STATE LEVEL ENVIRONMENT IMPACT ASSESSMENT AUTHORITY - TAMIL NADU

Inspection Report of the Committee constituted as per the Hon'ble National Green Tribunal (PB) order dated 26.02.2021 in O.A. No. 360 of 2015 – Sand Quarry in Palar River at SF No. 1588(P) Sakkaramallur Village, Arcot Taluk, Ranipet District

AUGUST 2025

Measuring at Temporary Bench Mark Reference Point

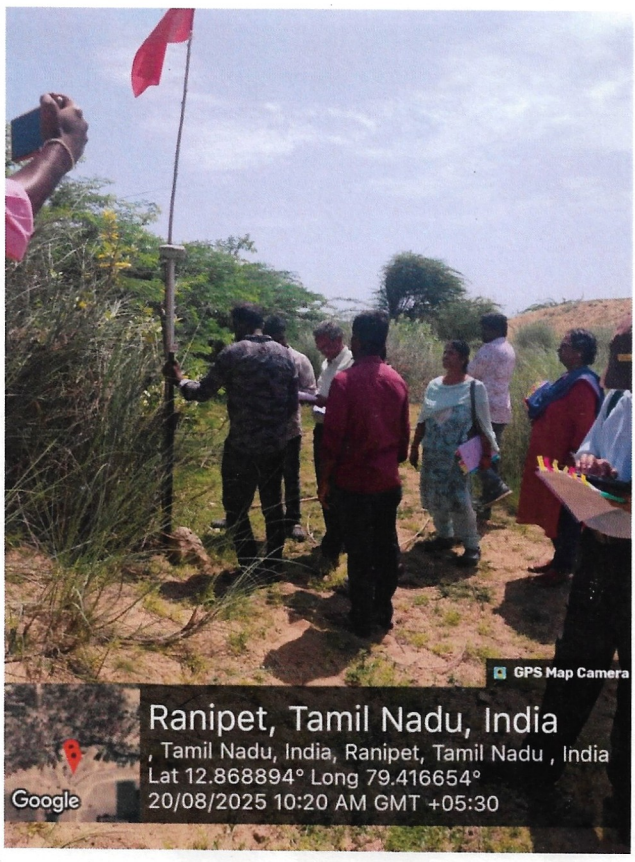
7. A temporary bench mark (TBM) was transferred from a permanent mark from the Palar Anicut. But the Proponent has not provided TBM with pillar for referring Mean Sea Level (MSL) at the site. However, during inspection they have shown Bench mark reference point marked near electric post on southern bank. From this point, MSL were transferred to the site. The latitude and longitude of the four corners were measured using Differential Global Positioning System (DGPS) instrument. The measured values are given below.

4. The Project Proponent shall construct and maintain a permanent bench mark concrete pillar at the mining site, clearly indicating the bench mark level with reference to Mean Sea Level (MSL), for monitoring of mining depth and compliance. Photograph shall be submitted before commencement of mining.
